Product/Process Change Notice (PCN)

PCN #: WL-SWTP_20160318
Product Affected: WE-SWTP
158301xxx, 158302xxx, 158563xxx

PCN Date: March 18th 2016
Effective Date: June 18th 2016

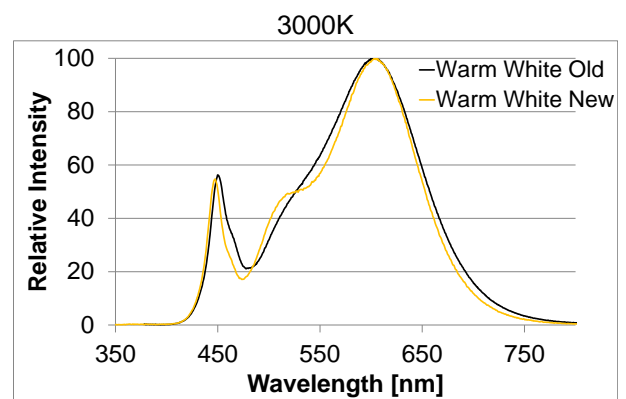
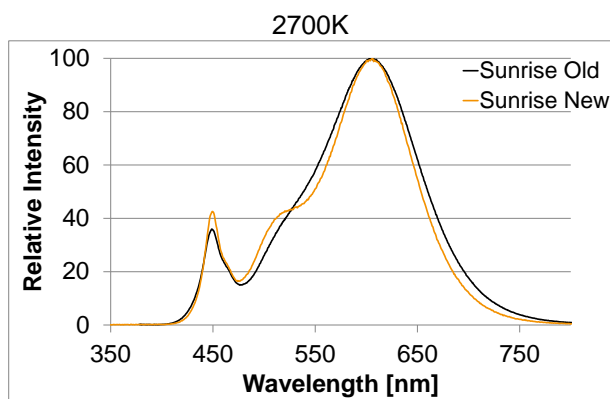
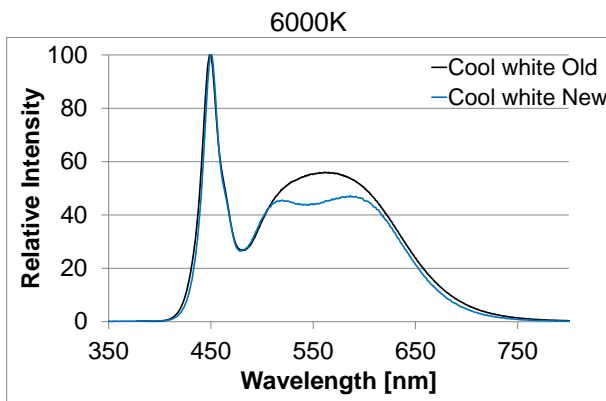
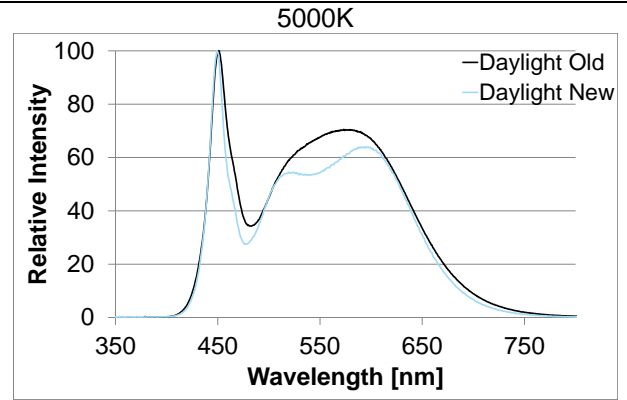
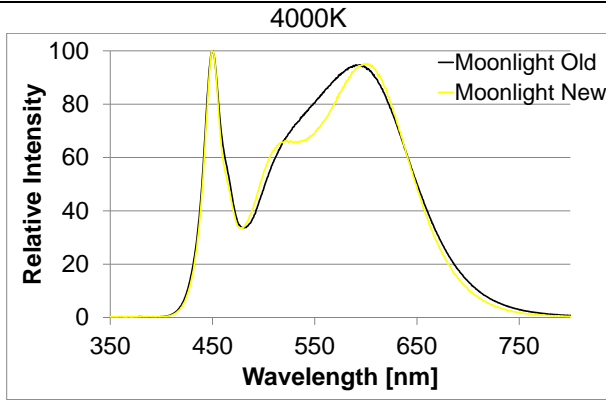
In order to enhance the product applicability, optical parameters have been improved.

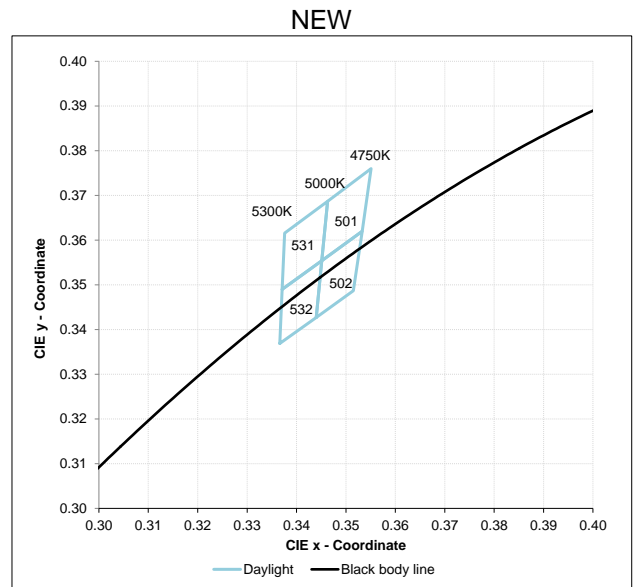
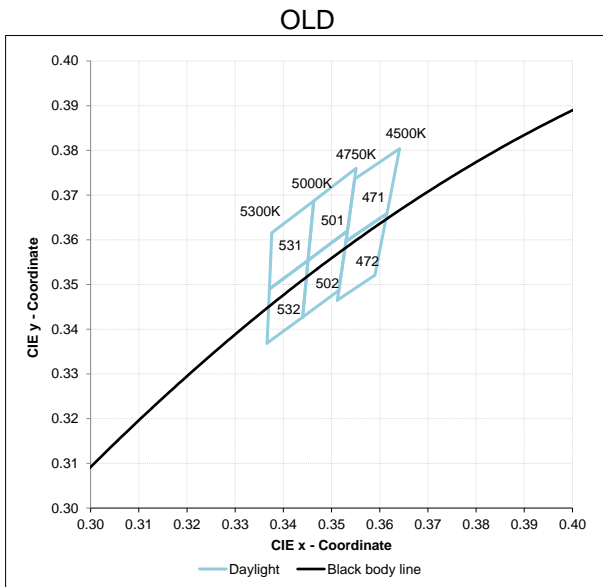
New product have improved optical spectrum and better light quality. The rest of the opto-electrical parameters have been adjusted to the product improvements.

For product series with 5000K - 158302250 and 158563450 binning table is improved trough better light output parameterization.

The Intensity curve vs. current is changed to relative value, for easier estimation of the output light for different currents.
